United States Patent and Trademark Office

APPLICATION NO.	FILING DATE	FIRST NAMED INVENTOR	ATTORNEY DOCKET NO.	CONFIRMATION NO.
09/961,114	09/20/2001	Donald V. Perino	RB1-035USC3	4507
29150	7590 01/20/2004		EXAM	INER
LEE & HAYES, PLLC 421 W. RIVERSIDE AVE, STE 500 SPOKANE, WA 99201			FIGUEROA, FELIX O ART UNIT PAPER NUMBER	
			2833

DETAILED ACTION

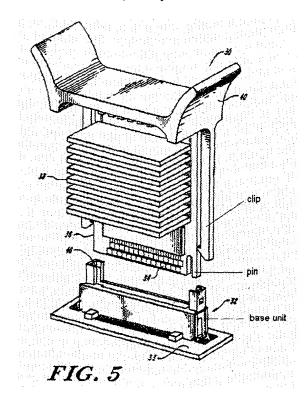
Regarding claim 97, see Figure in the section Response to Arguments.

In response to applicant's arguments that Bellomo does not teach a chip package, by contending that "the module is not itself a 'chip package' as recited", please note that Bellomo discloses (in col.4 line 24-26) that "[t]he module 36 includes a plurality of electronic circuits such as memory modules 38." Further, *The American Heritage® Dictionary of the English Language, Fourth Edition* defines "chip" as "[a]n integrated circuit", *Copyright* © 2000 by Houghton Mifflin Company. Thus, "the module" of Bellomo is a chip package comprising a packaging material having a first side.

In response to applicant's arguments that the lead shown by Bellomo is not "extending from the side of anything", please note that the leads (34) of Bellomo extend from a first side of the packaging material toward a second side, where the chips (38) are located.

In response to applicant's arguments that "the Office provides no location in Bellomo where such a 'clip' is discussed", please note that the clip is disclosed in Fig.5 of Bellomo, as subsequently shown.
